Crimson CPR1 Preamplifier Phono Stage

Under Development.  
 CPR1 Line Stage Including J-Fet Muting

## Updating the CPR1 PCB

The CPR1 (PCB code 35-15) is much improved with:-

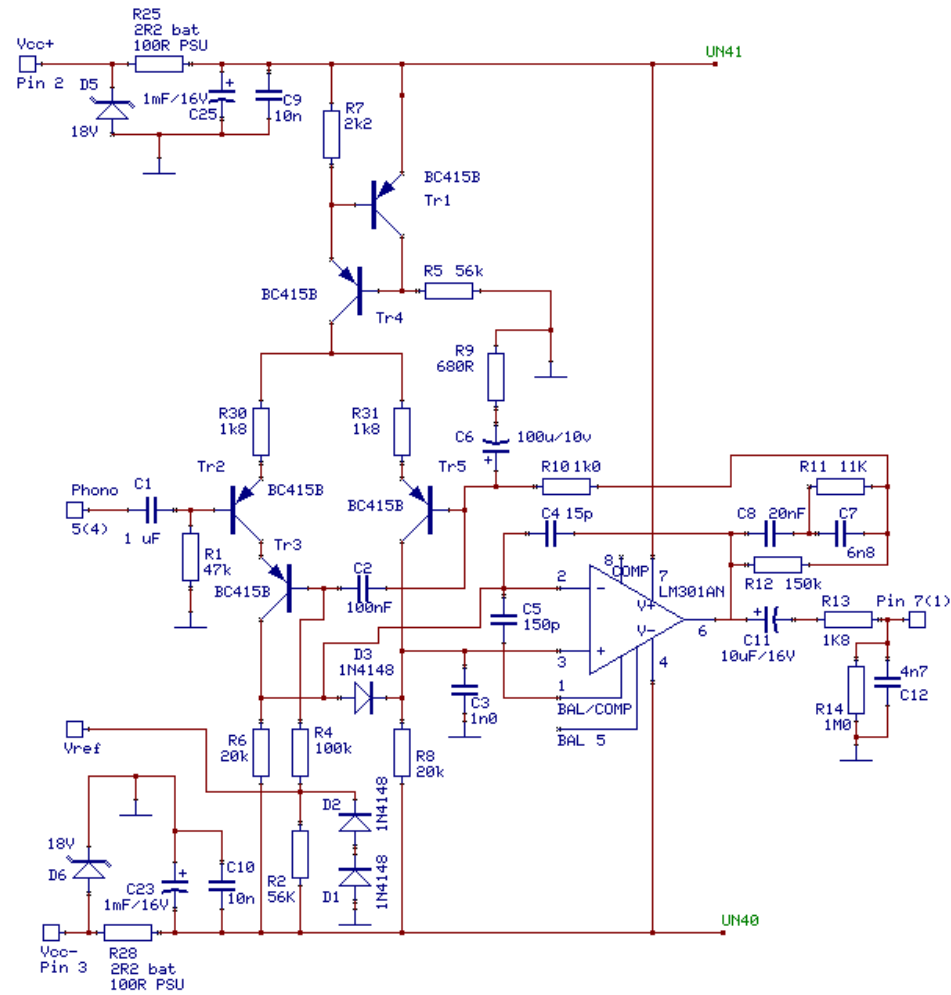
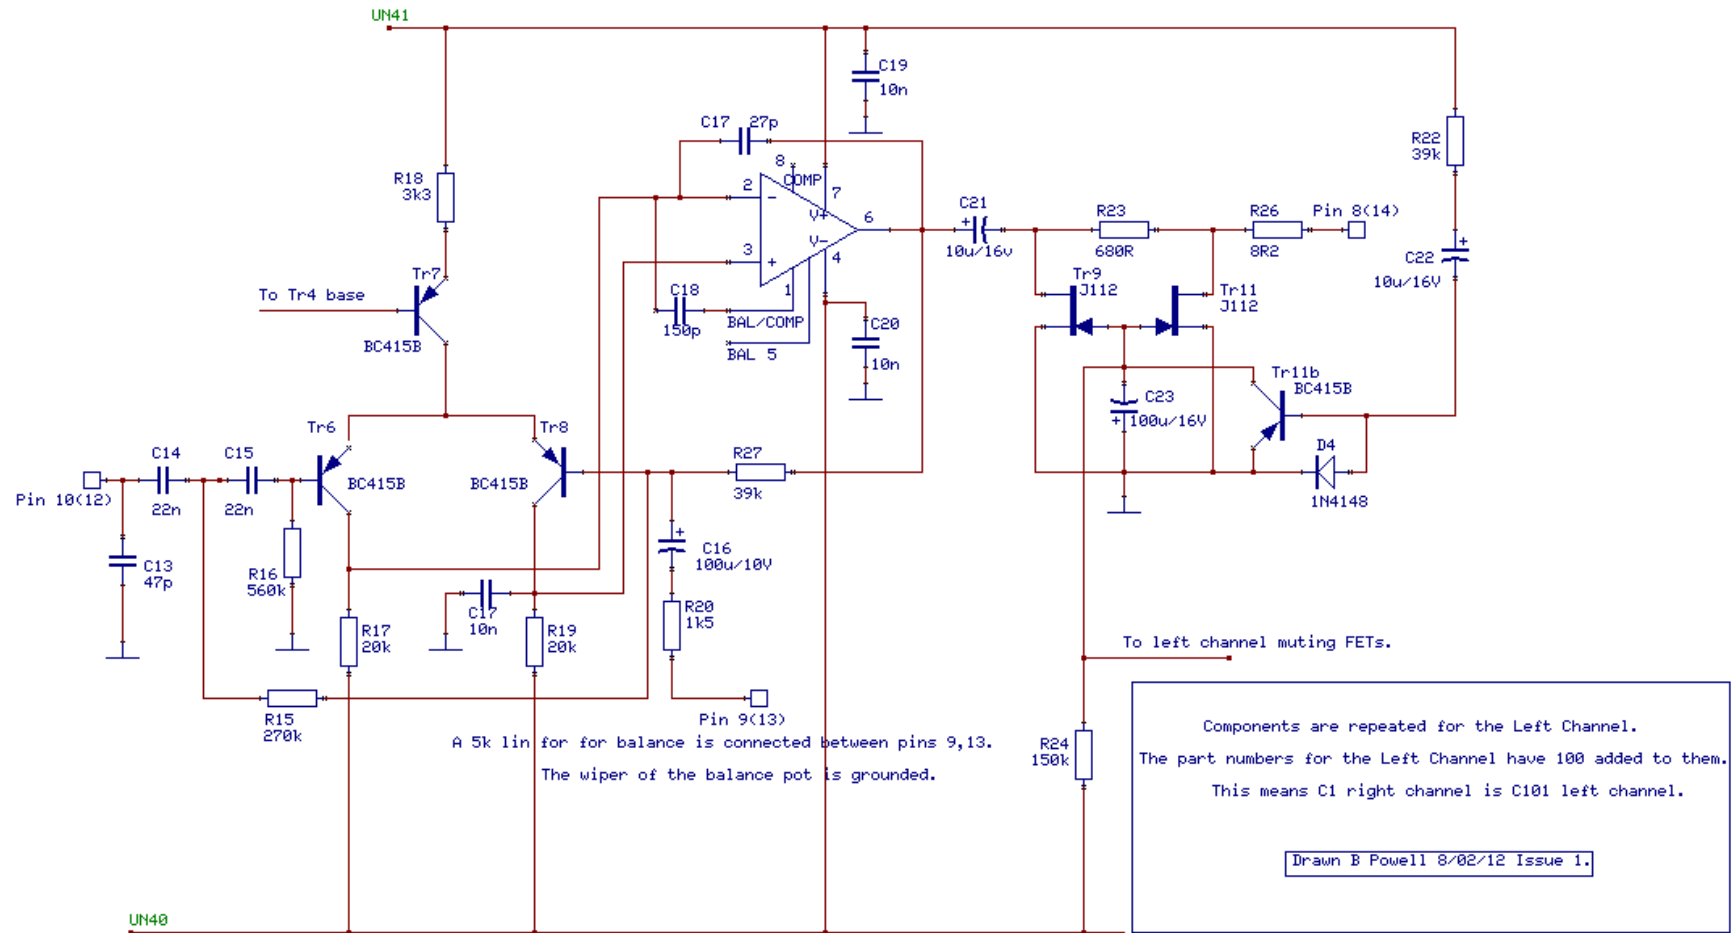
- More accurate RIAA for vinyl disc
- Faster, cleaner op-amps
- Removal of high pass filter in line stage. The original  $-3\text{dB}$  at 20Hertz was quite bass light.

1. Change C8, to polystyrene or polypropylene type if not already. The green ones are usually mylar 5% or 10%. The value is 20nF, so use 1% tolerance or select.
2. Check C7 . The ideal value is 6n86. Use 1% 6N8 or select. Polypropylene or polystyrene preferred. Possibly add 680pF (SMD) in parallel.
3. R12 should be 146.8K, use 150k parallel 6M8 or 147K in E96 series.
4. R11 should be 11.84K use 11K8 in E96 or 12k parallel 820K
5. Change C11 to 4u7 16V tantalum or low Z electrolytic in reverse to PCB silk screen polarity which was a polarity error.
6. Change C6 to 33uF/10V tantalum or 100uF/10V low ESR type polarity as per PCB ident (feedback DC block)
7. Remove C3 and C5, old compensation.
8. Change C4 to 10pF (stability)
9. Change R30 and R31 to 330R (were 1K8) to reduce noise (LTP degen)
10. Remove IC1 and replace with TLE2141CP.

11. Remove diode D3 and replace it with a series RC of 330R, 100pF
12. Replace R7 (1k8) with 680R (tail current to 100uA).
13. Replace diff loads R6, R8 with 68K
14. Repeat with left channel components (100 added to name)

7. Remove IC2, IC102 replace with TLE2141CP
8. Remove both C17 (adjacent Tr8) and C117 (adjacent R116) which are 10nF. The other capacitors marked C17 and C117 (by mistake) will be 27pF.

9. Change the 27pF C17,C117 to 10 pF.
10. Remove C18, C118
11. Remove C14, C114 replace with two 4u7& 16V tantalum with the negative terminal towards pin 10

12. Remove C15, C115 replace with 4u7/16V tantalum, negative terminal towards R16.
13. Remove Tr9, 109 and save as spare part muting FETs for Tr11,Tr111 (iss 1 only)

14. Change R26, R126 to 100R to help protect muting FETs
15. Change C16, C116 to 33uF tantalum or 100uF/10V low ESR type polarity as per PCB ident.
16. Remove R15, R115

17. Fit 2 x 18V ESD diode type P6KE18CA from each output pad to ground (drill extra 1mm hole in pad 11)
18. Remove Tr6,Tr8 (ditto LHC) and replace with J176 j-fets

19. Change R18,118 to 680R (tail current)
20. Change R17,R19 to 10k, LTP loads

1. Replace C23,C25,C123,C125 with the same value or higher but preferably with low ESR types.

Retest. Particularly for HF stability, May show as distortion.
